## II. THE SITE AND ENVIRONS

VEGETATION SURVEY OF THE  
INDIAN POINT ENVIRONS

FIGURE 1. Vegetation Survey of the Indian Point Environs

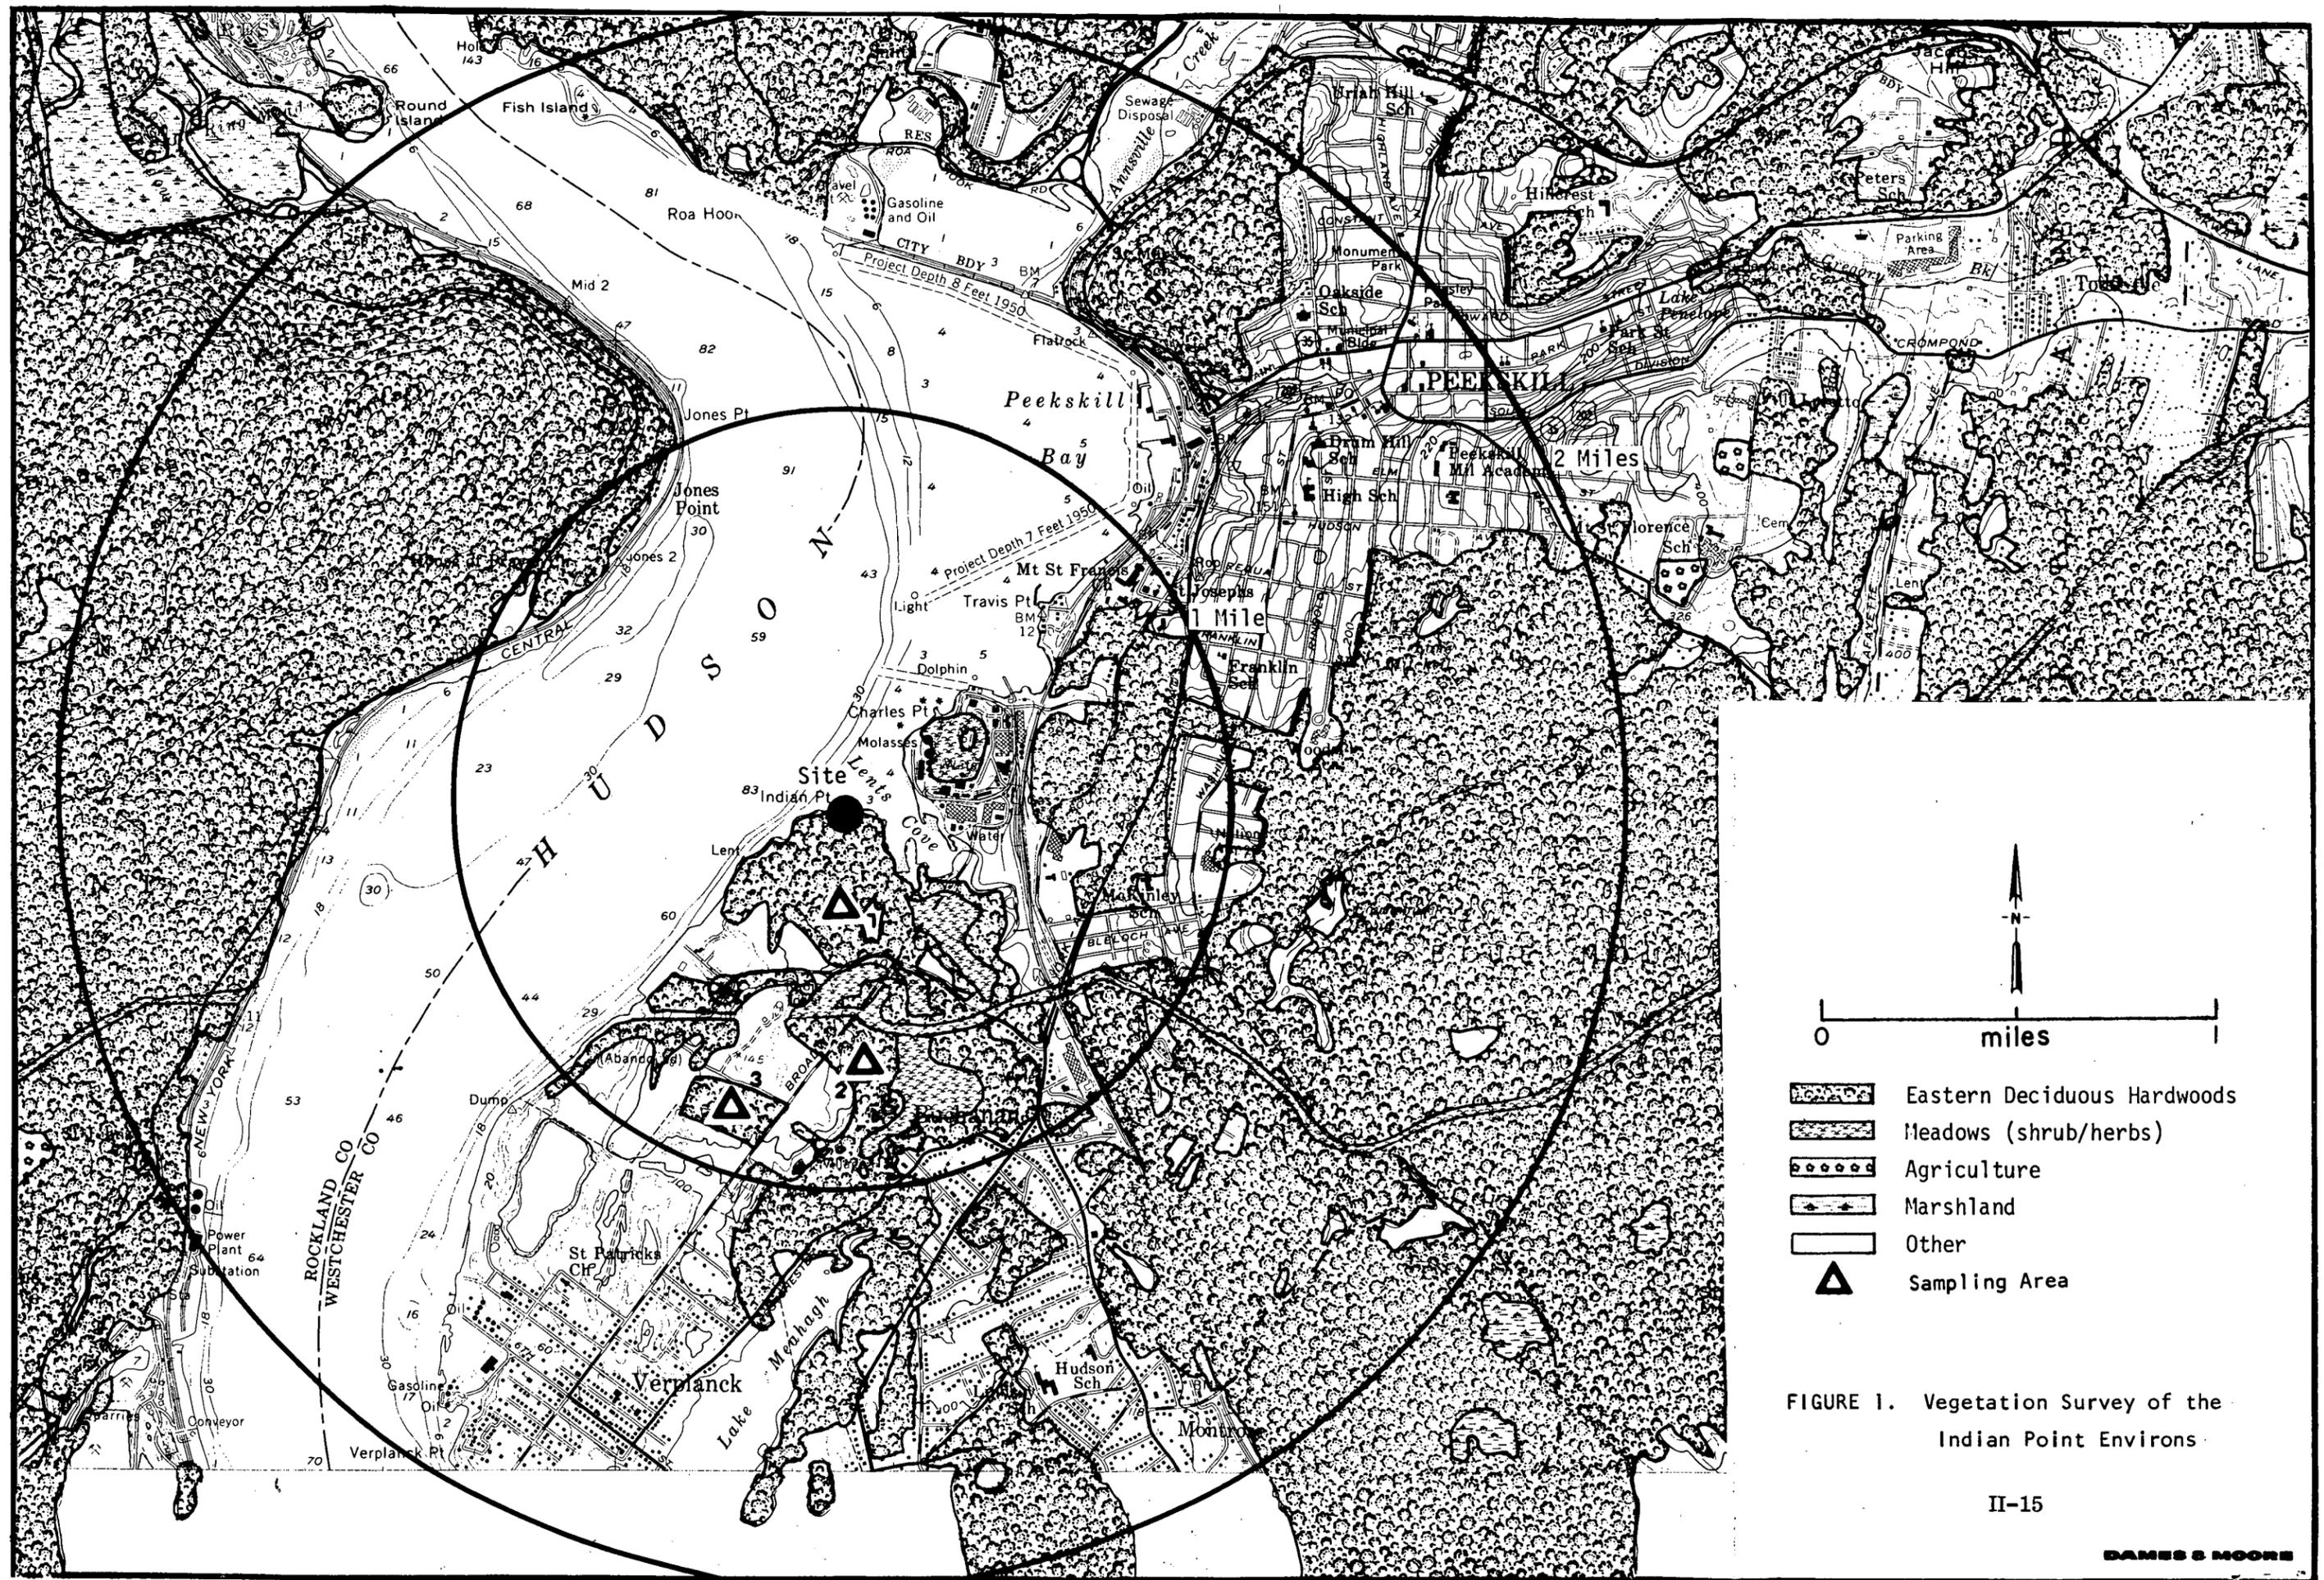
A vegetation survey listing species composition and relative abundance of major plant species within a 2-mile radius of the plant is required. All croplands, pasture areas, gardens, etc., occurring within a 5-mile radius of the plant site should be included. In addition, the approximate composition (species-%) of the proposed 80-acre natural area on the site should be provided.

A survey study of the vegetation in the Indian Point area, prepared for Con Edison by Dames and Moore, is attached. A 2-mile radius survey was conducted, as this is considered to be sufficiently distant to determine the maximum impact from cooling towers. No significant difference would be expected within a 5-mile radius. The composition of the 80 acre natural area is approximately the same as that described in the Dames and Moore report.

The Indian Point site is characterized by species of Eastern Deciduous Hardwood (Figure 1). The vegetation regionally is quite thick and has a dense canopy. The Eastern Deciduous forest is usually composed of several dominant stand types superior to an understory of less dense and well developed stands. The understory vegetation is moderately dense

Quantitative sampling was conducted at two locations (Areas 1 and 2) to the south and southeast of the site. The sampled areas are indicated by the triangles in Figure 1. An additional location (Area 3) was sampled qualitatively.

Area 1 is located 450 feet at 315° from the west corner of the small pond and is 10 feet square (Figure 1).

Area 2 is located approximately 2/10 mile southwest of the intersection of Broadway and Bleakley Streets on Broadway (Figure 1). All the species identified are listed in Table 2, and the number of trees 3 inches d.b.h. and greater are given as follows:

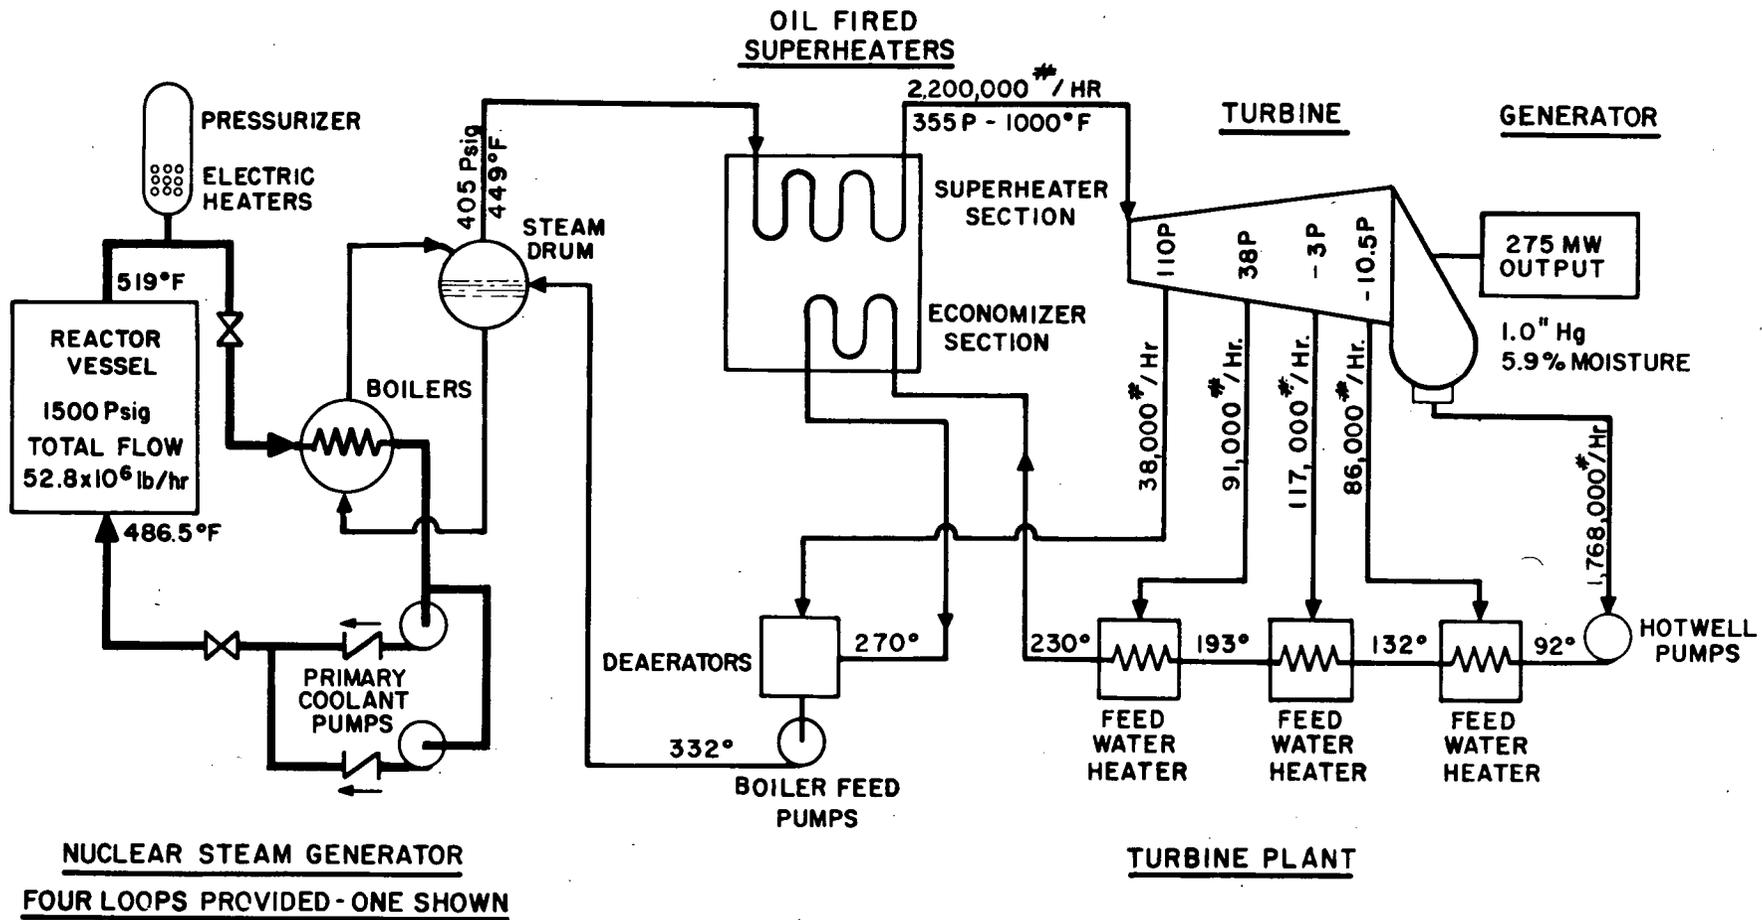
For Indian Point Unit No. 1 a schematic flow diagram (or equivalent description) for the steam and condensate systems and for the cooling and service water systems, showing flowrates and temperatures should be provided. Arrangement and flowrates in the deicing system should be indicated.

The steam and condensate systems are illustrated schematically on Figure III.A.1-1. Figure III.A.1-2\* shows the relationship between steam and condensate systems and the circulating (cooling) water system. Figure III.A.1-3 illustrates both the circulating (cooling) and service water systems, as well as the deicing system. The flowrates and temperature changes for Unit 1 are tabulated in Table III.A.1-1. Reduced flow conditions (i.e., when the ambient river water temperature is less than 40<sup>o</sup>F) is accomplished by throttling the pumps so that the circulating water flow is 60% of the full flow condition.

Deicing is accomplished, as seen in Figure III.A.1-3, by returning a portion of condenser discharge to the intake bays. Each deicing loop (there are two) is capable of returning up to 23,000 gpm.
